The Maryland-National Capital Park and Planning Commission  
 Prince George's County Planning Department  
 Development Review Division  
 301-952-3530

## NSR Properties

# DSP-19039

STAFF REPORT

Figure 1: North/Front Elevation

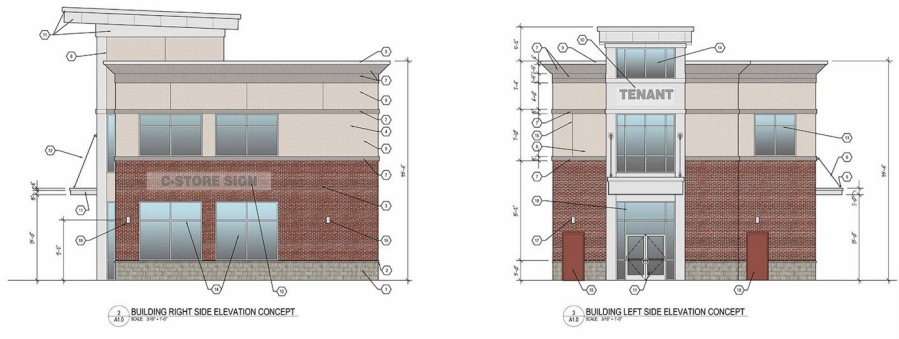
The proposed two-story, 9,592-square-foot building proposes a flat roof, which varies in height from approximately 33 to 41 feet. The façade of the building is composed of a combination of gray concrete masonry unit block that surrounds the base of the building, red brick veneer continues up to an expression line, and the second story is faced with sand colored exterior insulation finishing system (EIFS). The building has a ground-to-floor ceiling height of only 12 feet, which requires an amendment to the TDDP standard. The building is topped with a modern-styled EIFS cornice. Clear glass will be used in the store front windows, upper level windows, and doors. Each entrance will be composed of clear glass and gray metal paneling. The entrance vestibule projects from the building and will include building-mounted signage and metal canopies over the doorways. The side elevations continue the same materials and treatments as the front elevation.

- k. Integrate a mural or other equivalent artistic element into the proposed building, in accordance with the 2016 *Approved Prince George's Plaza Transit District Development Plan and Transit District Overlay Zoning Map Amendment* guidelines.

- l. Provide overhead awnings for all pedestrian and service building entrances.
- m. Provide details of the building-mounted signage and demonstrate conformance to all applicable 2016 *Approved Prince George's Plaza Transit District Development Plan and Transit District Overlay Zoning Map Amendment* standards.

Figure 4: Multi-Product Gas Dispenser Canopy Signage

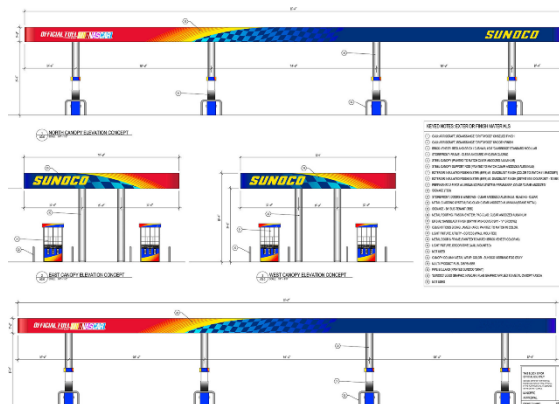
The gas station canopy is three feet tall and fully covered by signage and graphics on all sides. There are no standards for this type of signage as this type of use is not allowed by the TDDP. Signs not expressly identified in, or exempt from, the transit district standards are prohibited (page 193). If the use is approved by the District Council, the design of the gas canopy signage should be addressed to be more harmonious with the building design.

Figure 5: New and Existing Freestanding Signage

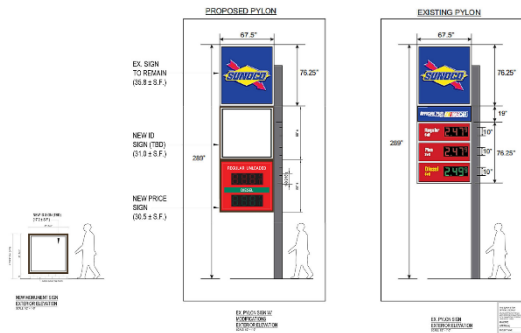
The applicant also proposes to retain the existing 24-foot-high, 97-square-foot freestanding sign and states that this sign is exempt from the TDDP, as it was lawful on July 19, 2016, and is not nonconforming. This exemption does apply currently, but the removal of existing structures and use on the property will make the existing sign no longer legal. The freestanding sign is currently located outside of the frontage zone and exceeds the 8-foot height and 3-foot width limits. A second, 4-foot-high, 17-square-foot freestanding sign is proposed along the Belcrest Road frontage. Both of these freestanding signs require an amendment to the TDDP standard.

- i. Remove both freestanding signs; all signage shall be affixed to the structures.
- j. Remove the proposed stand-alone automated teller machine (ATM) and associated drive-aisle; any proposed ATMs shall either be affixed to the building exterior or be located within the interior.

Figure 6: Belcrest Road (Toledo Terrace to Metro Entrance) Illustrative Street Section (page 215)

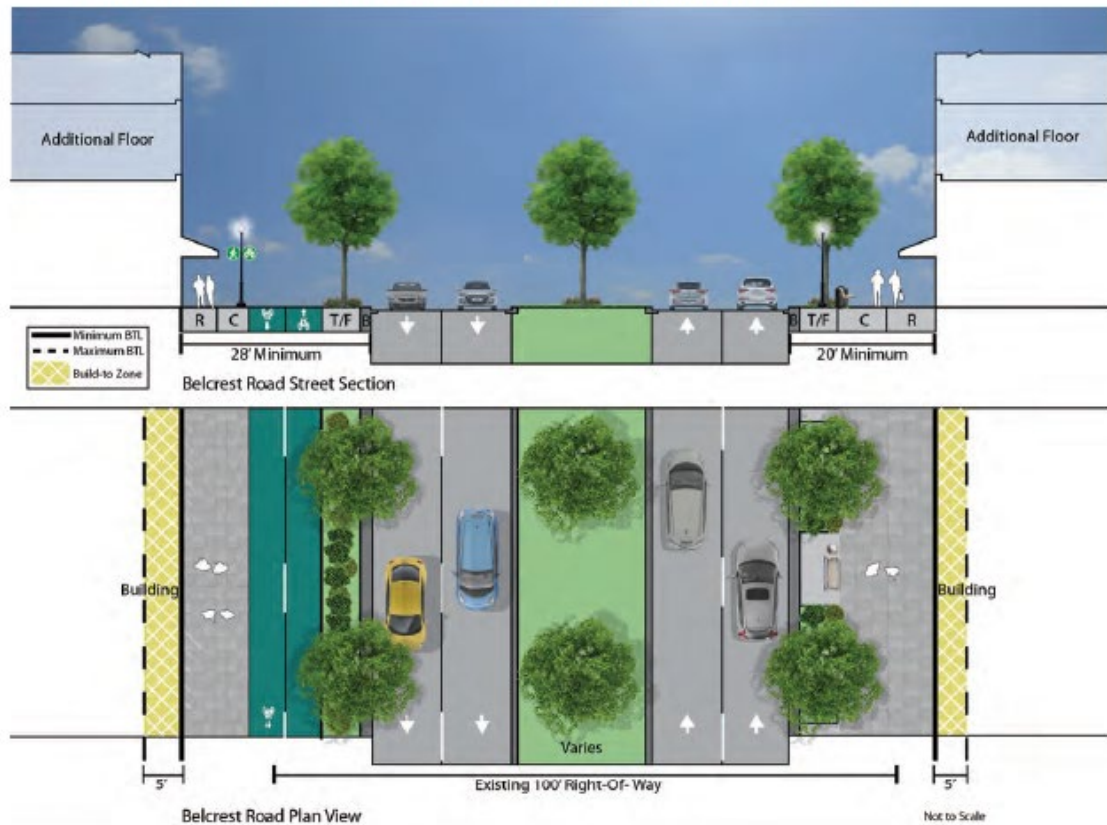
The TDDP also has specific guidelines for the frontage of Belcrest Road. The TDDP calls for a cycle track on the west side of Belcrest Road (the subject property). The cycle track shall be 10 feet wide and adjacent to the sidewalk (TDDP page 89).

The applicant shall provide a 10-foot-wide cycle track along their frontage of Belcrest Road, consistent with the TDDP. The frontage along Belcrest Road is required to have 5 feet of Tree and Furnishing Zone, 5 feet of Sidewalk Zone, and a variable width of Retail Zone; totaling a combined minimum depth requirement of 28 feet (including the above-mentioned cycle track) (TDDP page 211).

- c. Provide a 10-foot-wide cycle track along the frontage of Belcrest Road, consistent with the 2016 *Approved Prince George's Plaza Transit District Development Plan and Transit District Overlay Zoning Map Amendment*.

**Figure 10. Belcrest Road (Toledo Terrace To Metro Entrance) Illustrative Street Section**

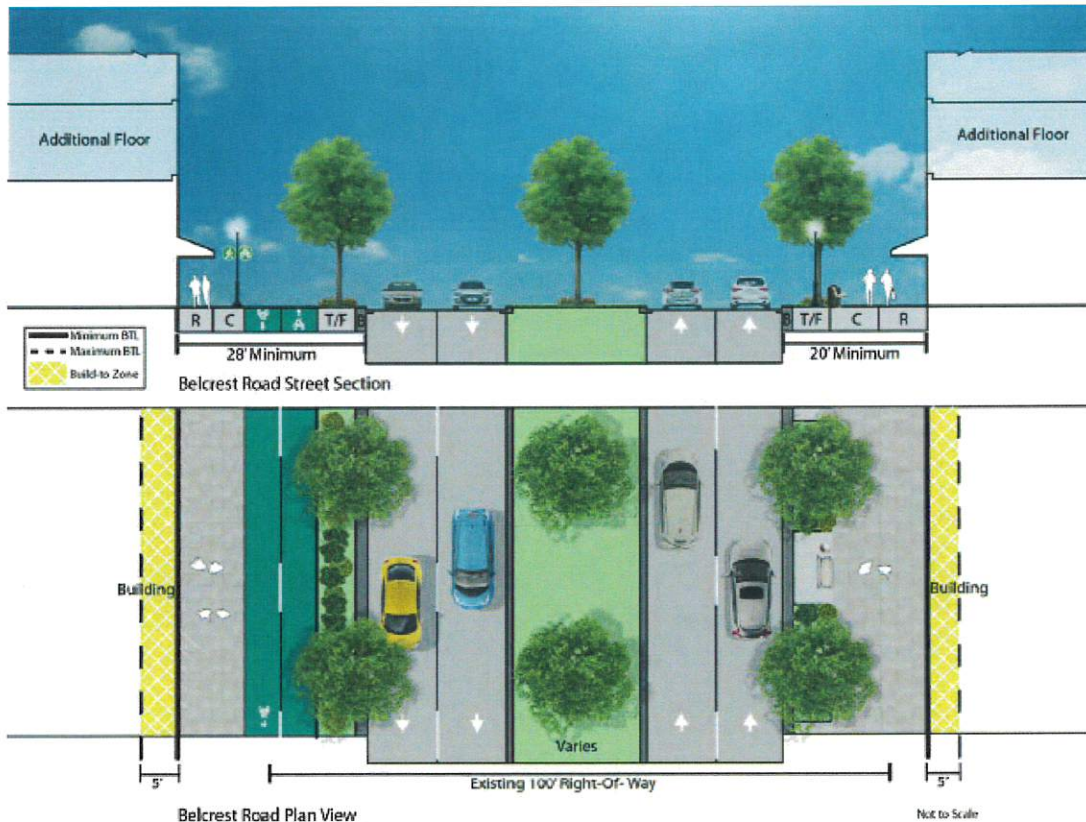
The TDDP also has specific guidelines for the frontage of Belcrest Road. The TDDP calls for a Cycle Track on the west side of Belcrest (the subject property). The cycle track shall be 10 feet wide and adjacent to the sidewalk. (TDDP p. 89).

**Comment:** The applicant shall provide a 10-foot wide Cycle Track along their frontage of Belcrest Road consistent with the TDDP. This improvement should be depicted on the future DSP submissions.
